**SERVICE BULLETIN**

**APPLICABILITY:** 2020-21MY Outback

**NUMBER:** 12-322-21

**SUBJECT:** Cross Bar Integrated Roof Rails – Warped/Wavy Finish

**Effected Area of Rail Cover**

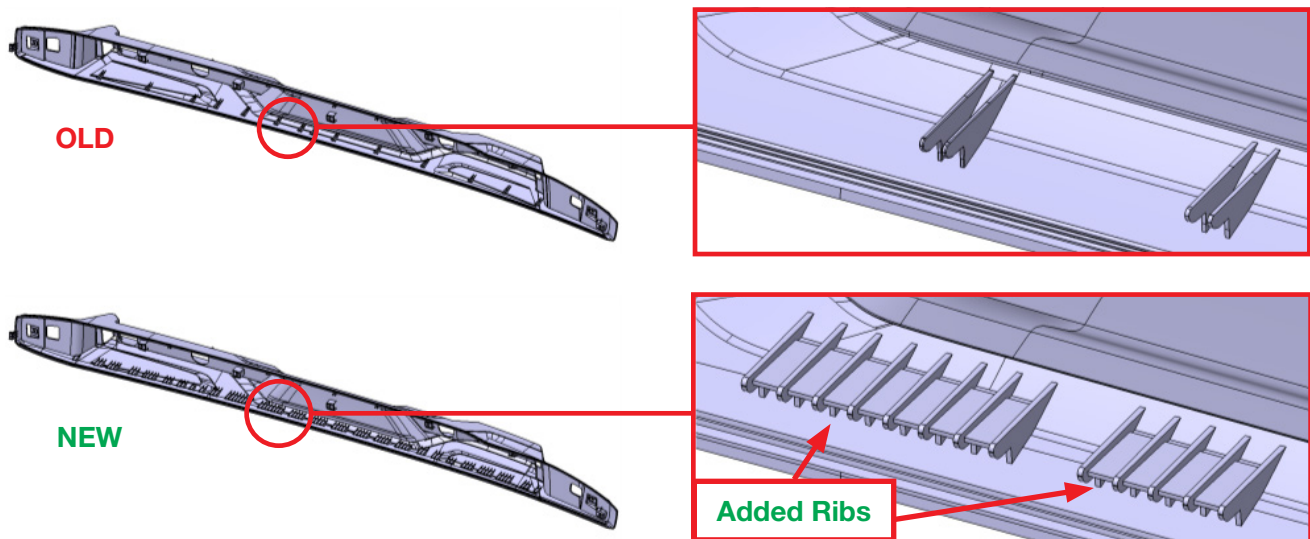
This bulletin announces a design change made to the cross bar integrated roof rails. The new roof rails have added reinforcement ribs on the bottom of the rail cover section. The ribs enhance the roof rail rigidity and prevent any “warped” or “wavy” appearance of the rail cover. This condition can be caused by high ambient temperatures and / or extreme sunlight exposure.
